PLAN COMMISSION / ZONING BOARD OF APPEALS AGENDA

Future Public Hearing Request: Special Use Permit for a self-service storage facility in the I-2 General Industrial District, Special Use Permit for extended hours of operation, Zoning Variations pursuant to parking and loading requirements (Article 7 Section B), Preliminary and Final Plat of Resubdivision (to consolidate lots and tax parcels), and approval of a retaining wall's height and length (PINs: 19-09-34-103-008-0000, 19-09-34-100-065-0000, and 19-09-34-100-064-0000).

E FACILITY PLAN INDUSTRY AVENUE STORAGE
PRELIMINARY ENGINEERING
FRANKFORT, IL

Dwg: Pres301

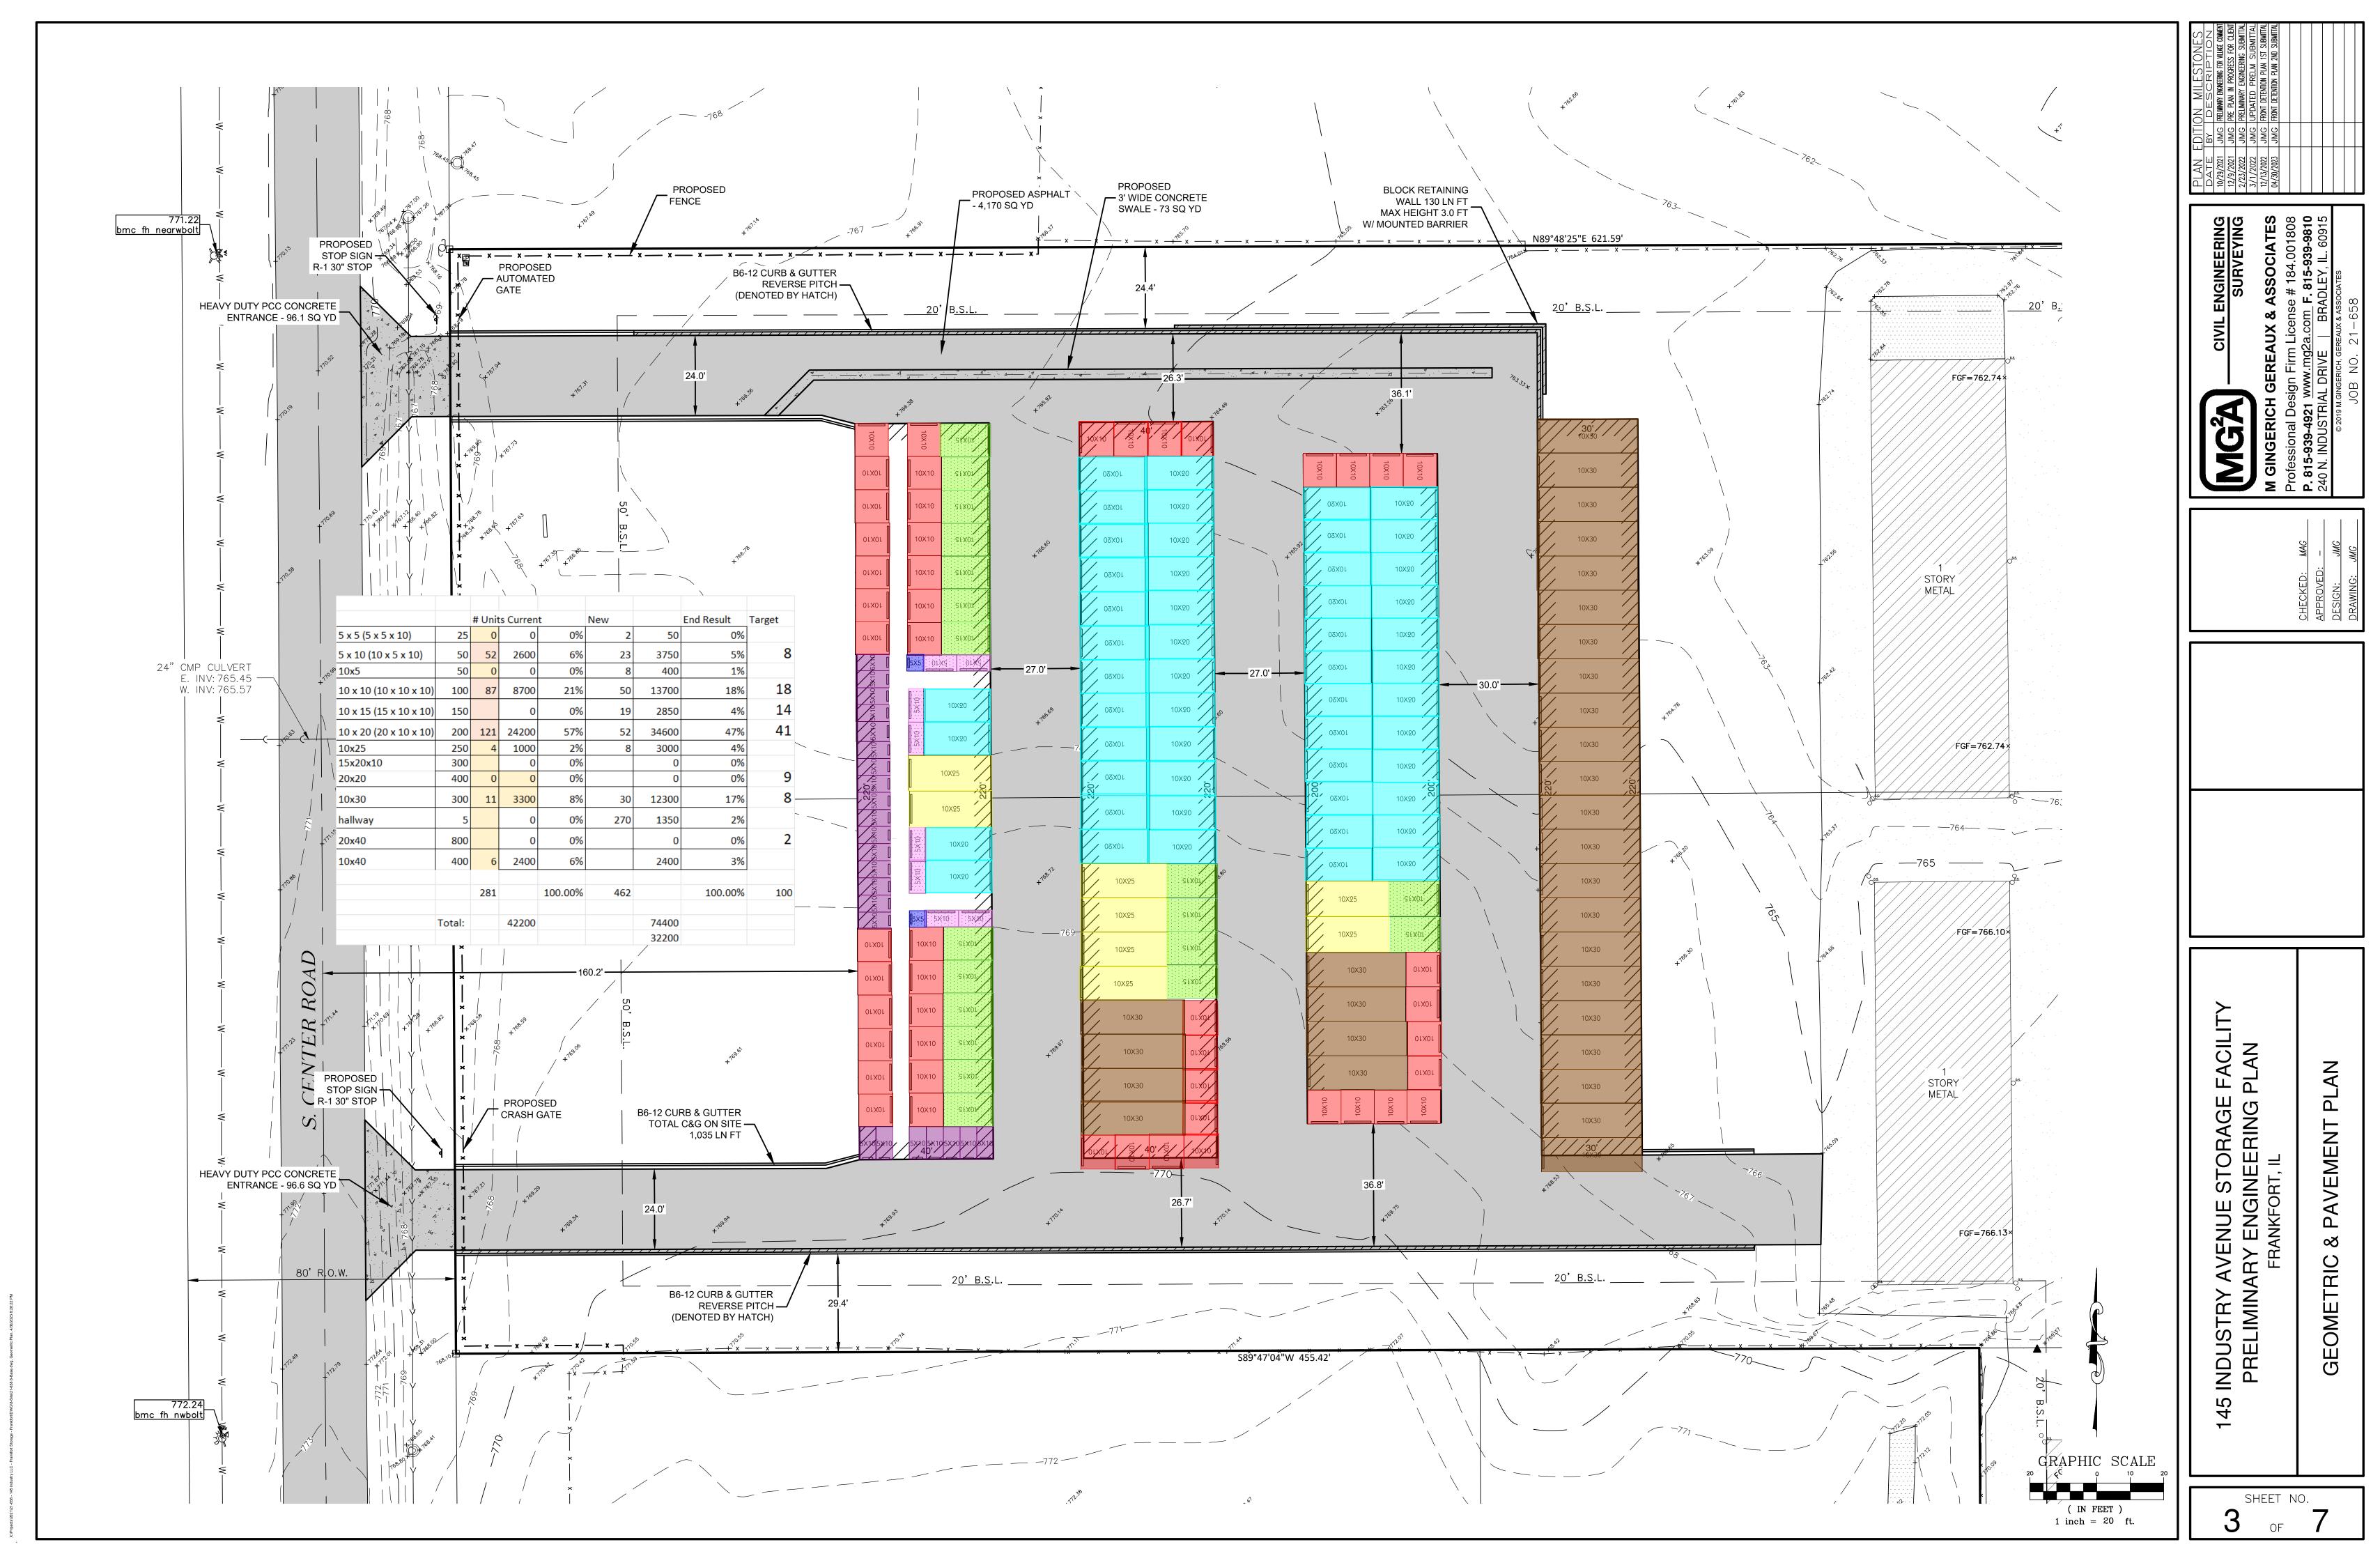
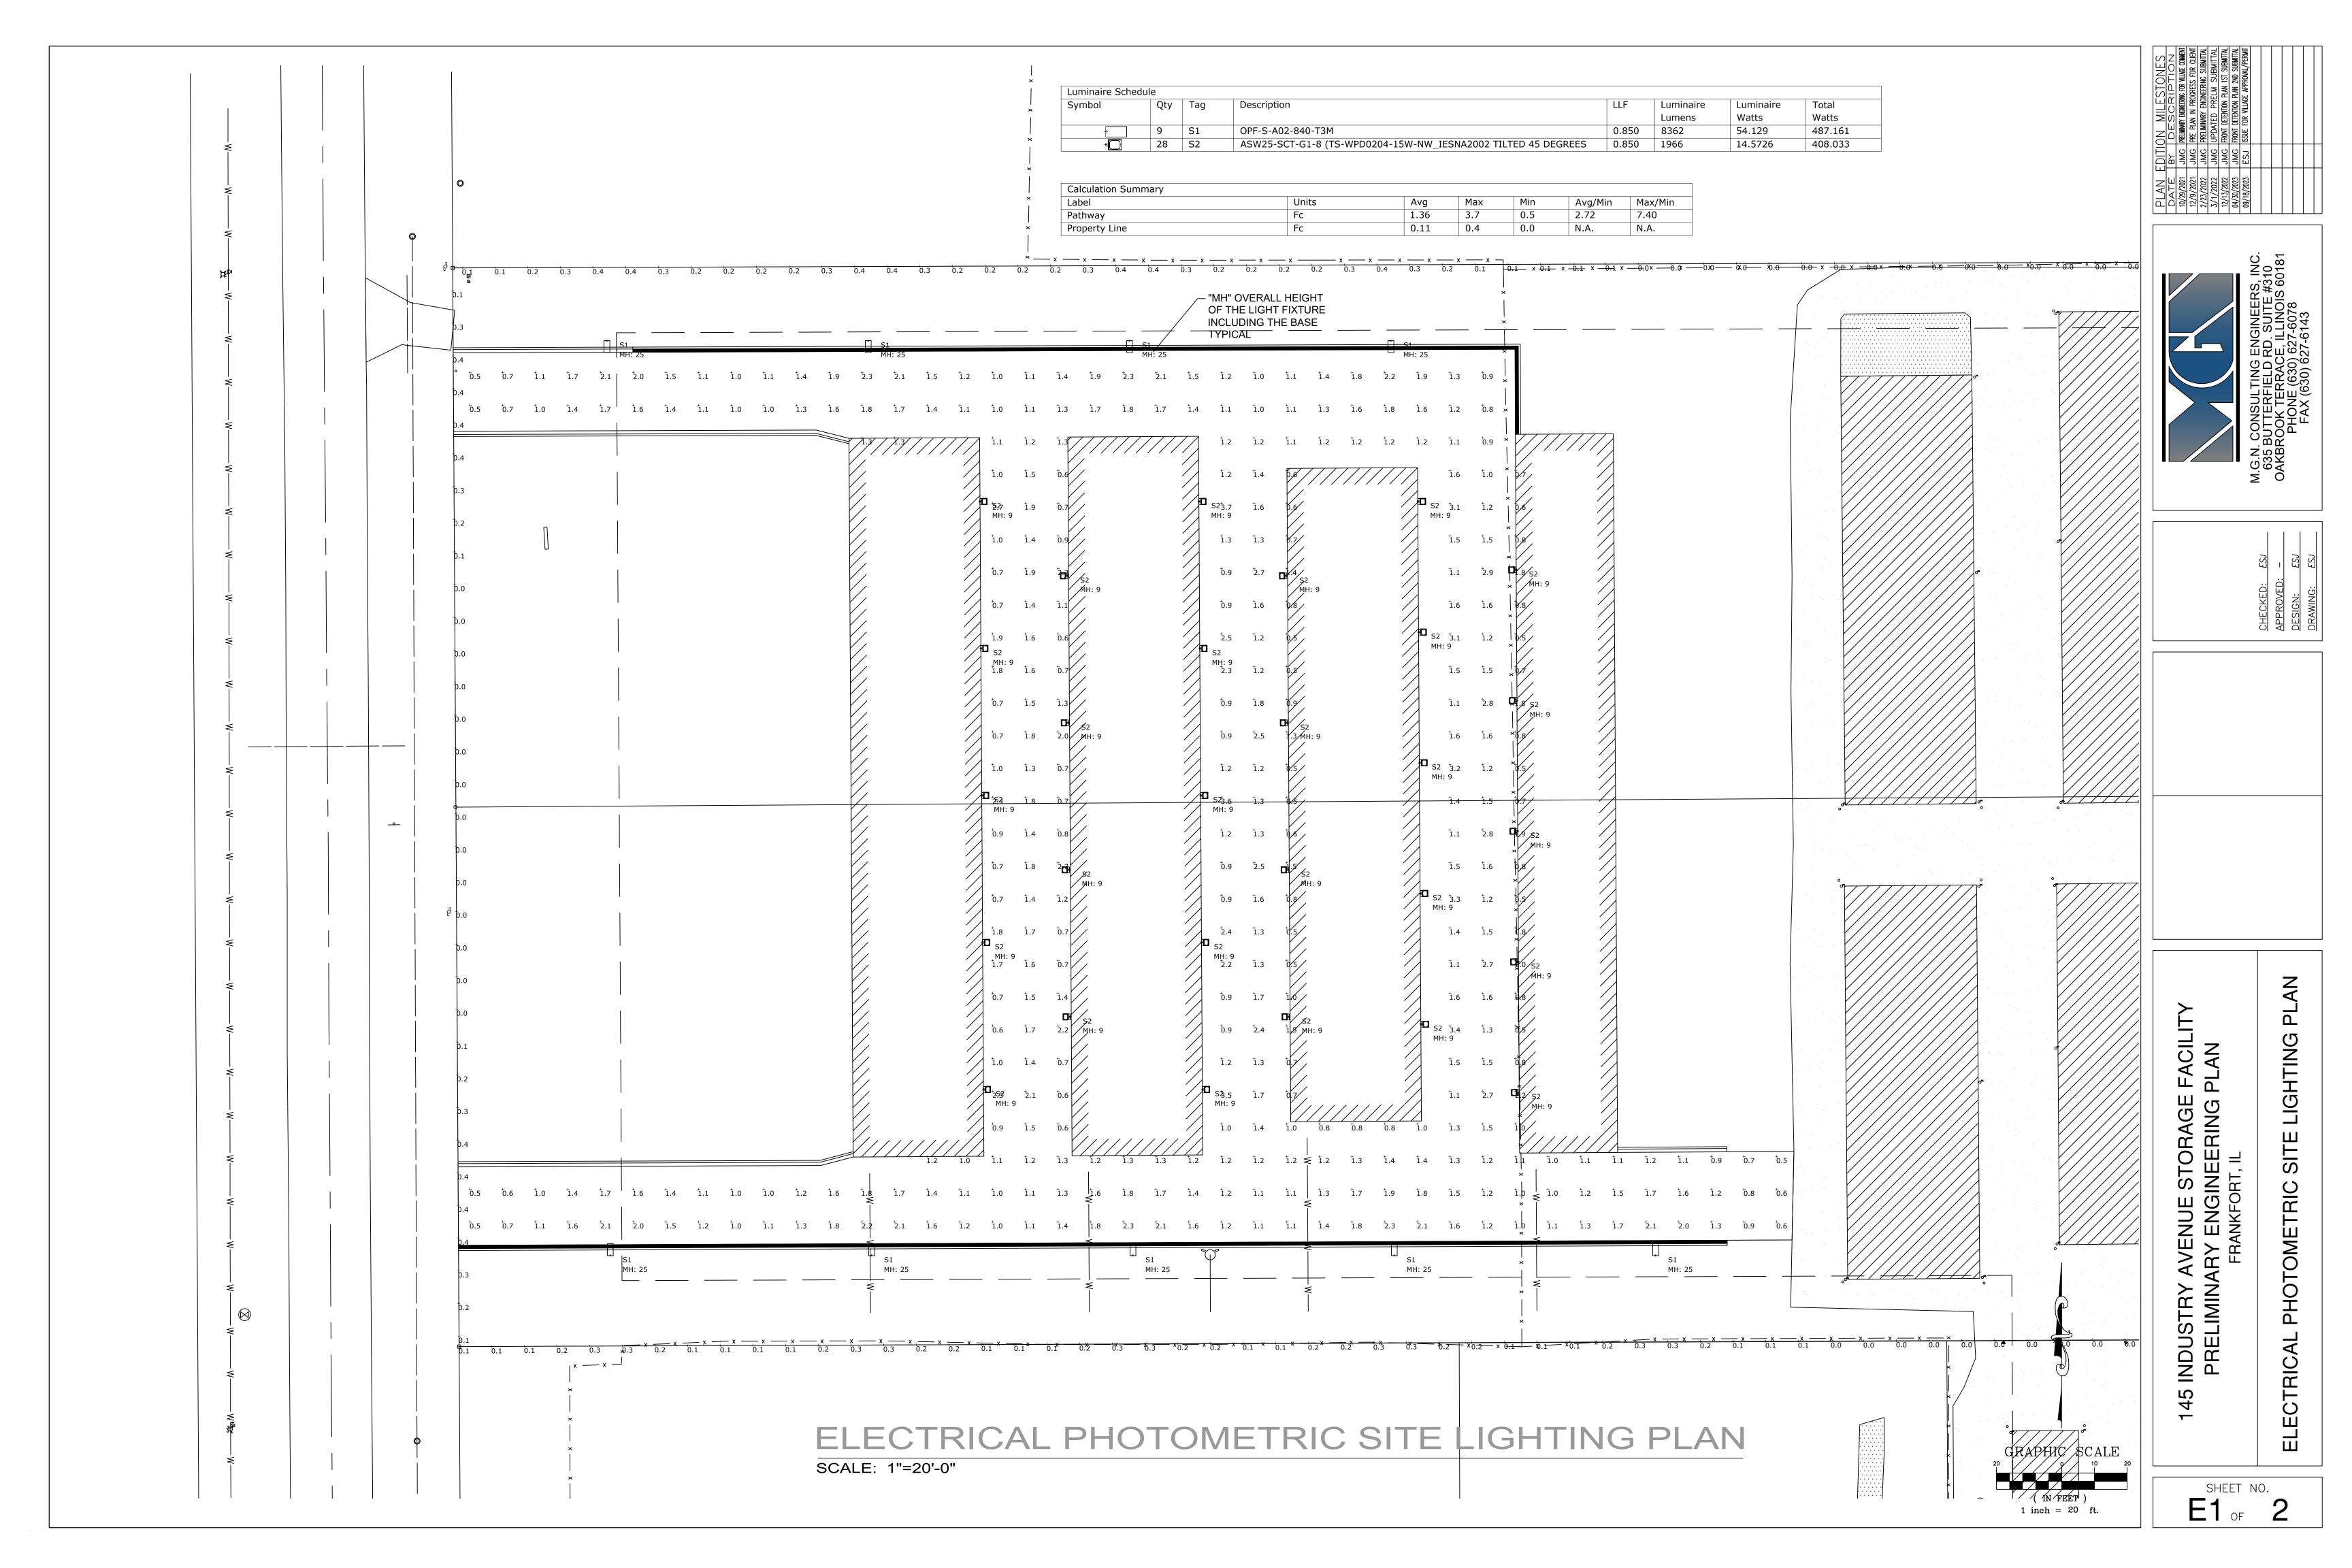
- a. Please show the sign locations on the site plan and landscape plan.
 - b. It is recommended to replace the existing sign on Center Rd. to match the new sign on Industry Ave. to ensure that the signs show some uniformity.

- c. The material of the sign should match the material of the building (i.e. stone or metal), please revise the cabinet style sign.
 - d. The sign regulations limit the amount of information on a freestanding sign. The email address will need to be removed. Please confirm if "cantenbury boat/rv" is proposed for consideration (as it is not applicable to the proposed use).

- e. The sign ordinance states only 3 colors are allowed, please revise the 5 colors shown on the sign.
 - f. Please indicate the height of the lettering on the sign.

PARKING LOT LIGHT BASE DETAIL

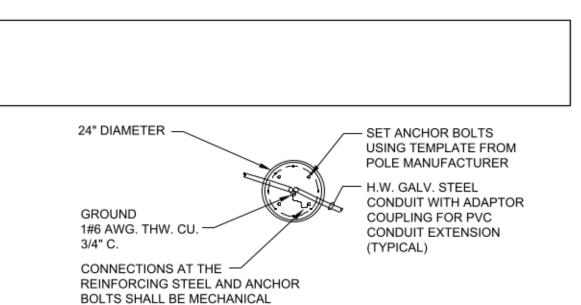
- Staff requested less pixelated specifications for the free-standing light poles as they have been provided on the engineering plans.
- 4. The Village's Municipal Code states that parking lot light poles shall be treated as a decorative element and be in design with the proposed buildings (i.e. stone base to match the stone on the building). The light pole details on the engineering plans show that the light poles will have a round concrete base. Staff recommends incorporating a decorative base on the light poles.
- 5. The free-standing light poles are also LED and cut-off. It does not appear that the applicant has yet selected the color of the light poles. Staff recommends that the color match the wall mounted light fixtures.
